Subject: Notice of NPNS Focus Report and request for feedback

Northern Pulp Replacement Effluent Treatment Facility Project Focus Report – Environment and Climate Change Comments, November 8, 2019

Subject: Health Canada's Response to the Focus Report for the Replacement Effluent Treatment Facility Project for Environmental Assessment.

Figure 1 Town of Pictou Source Water Protection Committee Delineated Boundary (Town of Pictou, Pictou / Caribou Source Water Protection Plan 2017, NSE webmapping)

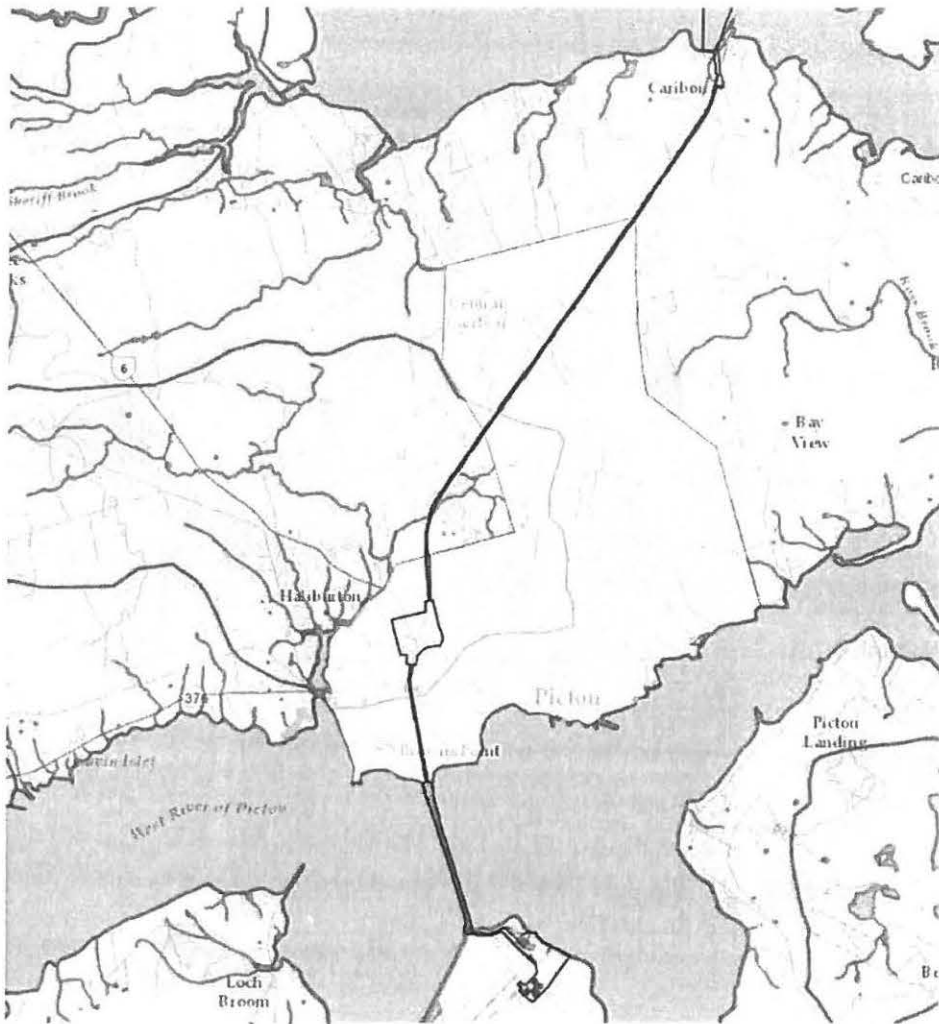
developed a Source Water Protection Plan (latest revision Oct 2017) to address potential risks. Potential risks related to pipeline routing are not specifically addressed. The attached Figure 1 here shows the SWPA delineated boundary. In comparison to Figure 2 (pipeline route also attached) it can be seen the pipeline route along Highway 106 crosses the SWPA delineated boundary in two areas.

Figure 2 Proposed Pipeline Route 500 m radius buffer zone and water wells (NS Groundwater Atlas, Energy and Mines 2019)

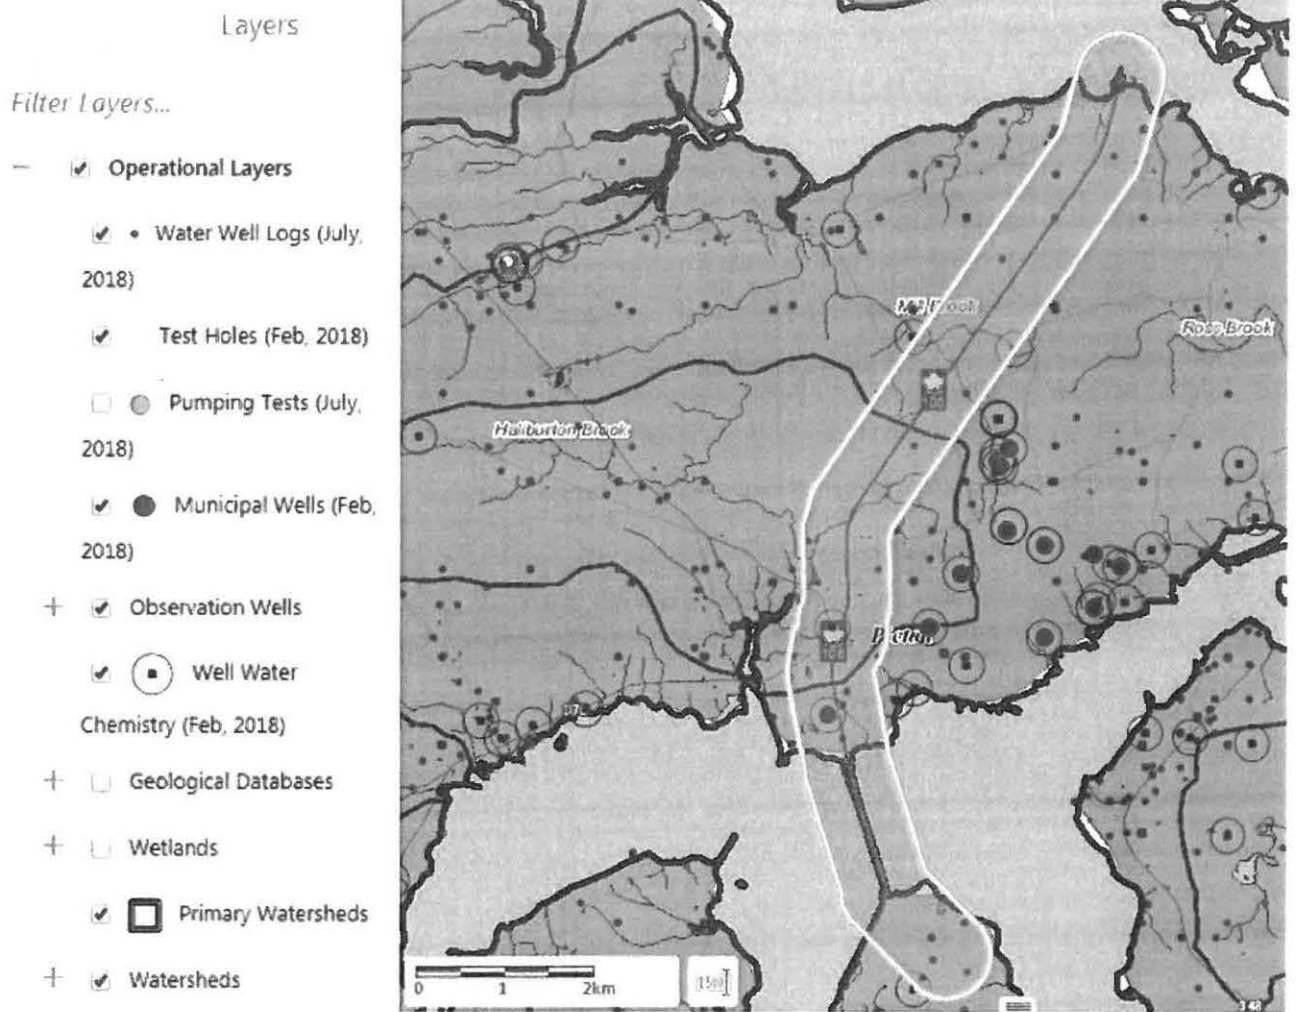
6. The online Nova Scotia Groundwater Atlas (Energy and Mines) was used (by this reviewer) to estimate the number of residential drilled wells within a 500 m radius buffer (on either side) of the proposed pipeline route from the ETF to Caribou. See the attached Figure 2 showing the 500 m buffer zone. The Atlas identified 62 water wells within the 500 m buffer distance. The majority of these are identified as for domestic use, but two are listed as public (non-municipal).
